**Re: PA23-012 – English Crossing Townhomes – Technical Review @**

SUBJECT: PA 23-012 – English Crossing

To: Merle Ash, Land Technologies  
From: Don McGhee, Assistant Fire Marshal  
Date: August 22, 2023  
Subject: PA23-012 English Crossing Townhomes 17406 19<sup>th</sup> Avenue NE

RE: English Crossing, File# PA23-012  
247 New Townhomes  
17406 19<sup>th</sup> Ave NE & Parcel # 31051900401200

**CIVIL SITE PLAN**

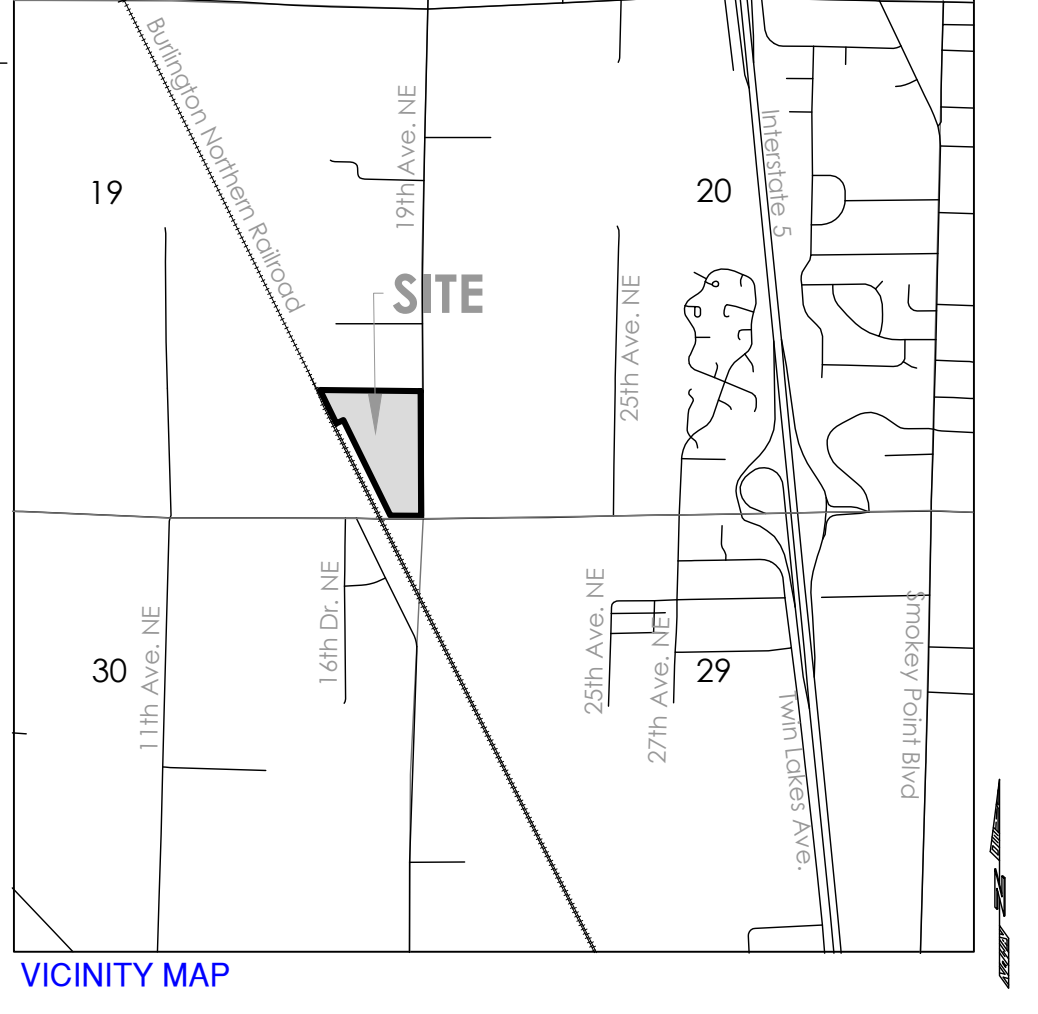
**The maximum hydrant spacing allowed for MU/MF use is 300' apart. The spacing of fire hydrants shown on the Civil Plan is not adequate, add two more to make spacing work. I have attached the site plan with the desired placement of all hydrants with two hydrants added. A revised site plan will be required for review.**
